Re: SCG and SDGE Comments on Draft Regulation Proposal for Greenhouse Gas Emission Standards for Crude Oil and Natural Gas Facilities

Attachment
Proposed Regulation Review (by section)

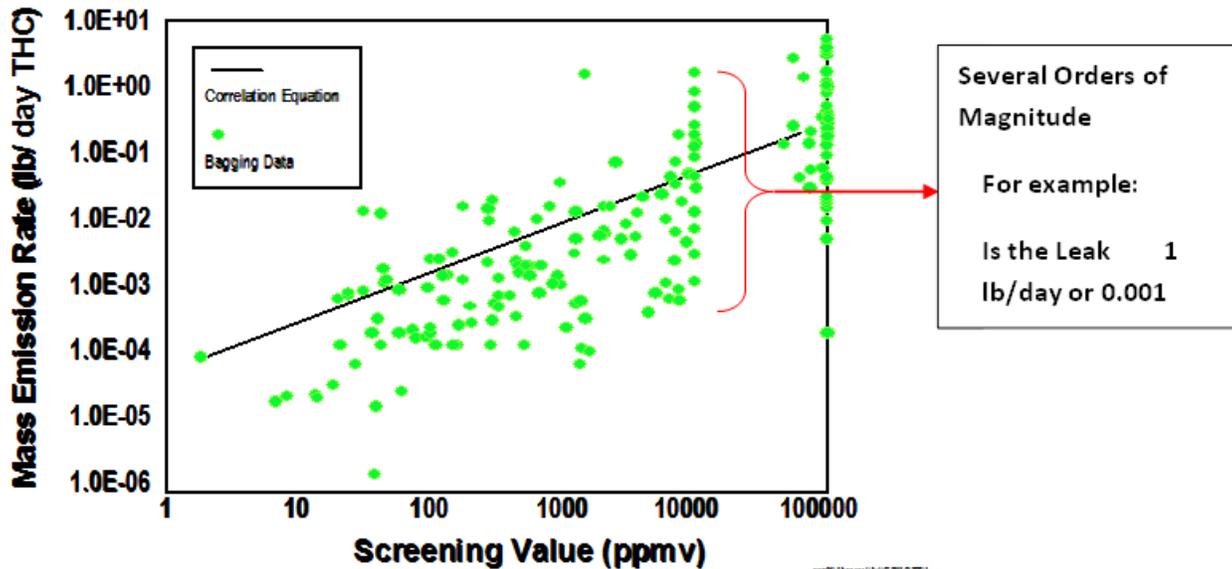
The low leak rates determined by these measurement data are consistent with studies completed by EPA, the Gas Research Institute (GRI) and others. Figure 1 plots measured leak rate data from EPA against associated Method 21 screening values, and shows a correlation equation developed to estimate emissions from screening data. Table 3 summarizes leak rate estimates based on this correlation equation. The leak rates are one to two orders of magnitude lower than

measured by the CSUF study.

Figure 5.2.1.1: Leak Rates vs. Screening Values of All Leaking Components

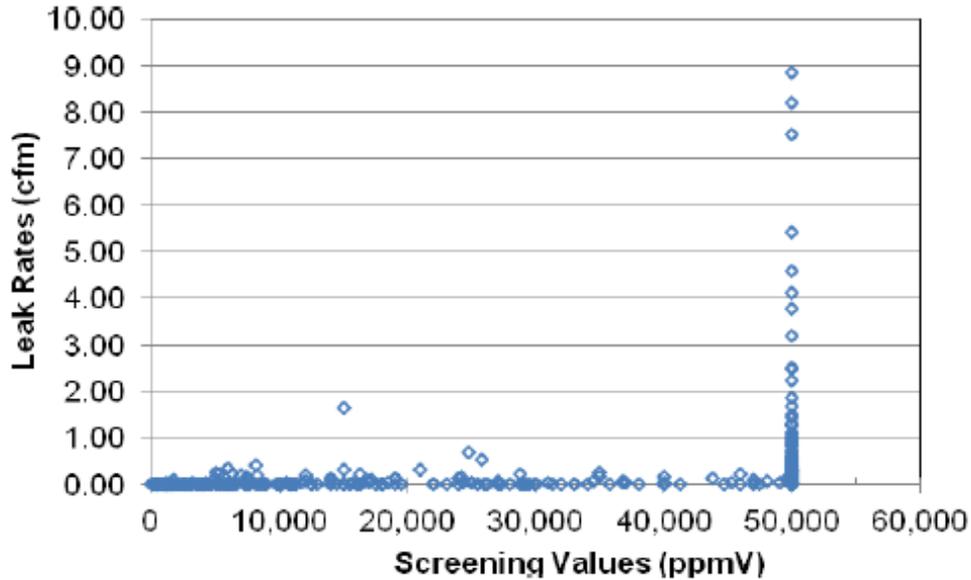
At workshops for the proposed rule, several attendees commented that the minimum threshold for repair should be lowered from 1000 to 500 ppm. However, there is no technical basis for this. Presumably, a criterion for VOC was extended to methane; but this is not appropriate because the concentration of methane is higher in the sample matrix. Method 21 sampling rate will pull in more methane than diluted VOCs. Based on data collected under a California Energy Commission Project by California State University Fullerton (CSUF), 50,000 ppm would be an appropriate minimum threshold. Although there were some concerns with the emission factors calculated in study, the concentration and flow rate measurements taken by CSUF are representative of actual leaks in California gas systems. The report provides many graphs that show no correlation of concentration vs. flow. In the CSUF report, Figure 5.2.1.1 provides a graph of all the concentration vs. flow data, and Table 5.2.1.2 parses the data into specific ranges based on concentration. This figure and table are copied below.

In the spreadsheet below, the Counts in Figure 5.2.1.2 are multiplied by the average leak rate to calculate the total leak for each range of concentrations. An 89% reduction would be realized with a threshold of 50,000 ppm. Selecting 10,000 ppm as the minimum threshold would result in 96% reduction. By going down to 1000 ppm, you only pick up an additional 3% reduction. Dropping further to 500 ppm as proposed by some at the workshops, results in far less than 1% additional reduction. It is unlikely that repairing leaks below 10,000 ppm, let alone 1000 ppm are cost effective. The threshold for repair should be set no lower than 10,000 ppm.
